NOTICE OF PROPOSED CHANGE IN PROPERTY

Petition: x512✓

| B           |  |           |      |          |      | REQUEST TO ENCROACH<br>INTO A PORTION OF HUNINGTON RD.<br>IN THE BLOCK BOUND BY<br>EDINBOROUGH, SEVEN MILE W., GRANDVILLE RD.<br>MARGARETA AND CLARITA AVE.<br>(With Monitoring Wells) | <b>CITY OF DETROIT</b><br>CITY ENGINEERING DEPARTMENT<br>SURVEY BUREAU |  |

| DESCRIPTION |  | DRWN      | CHKD | APPD     | DATE |  | DRWG. NO. X 512  |  |

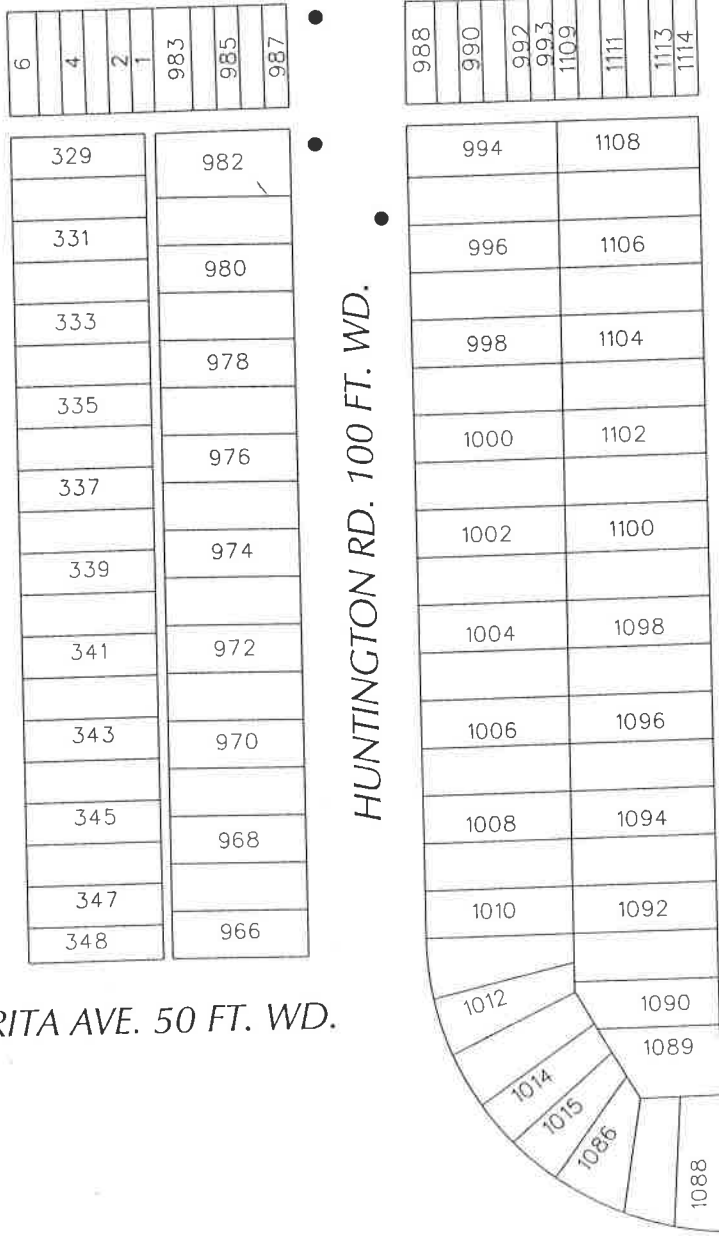
NO VG
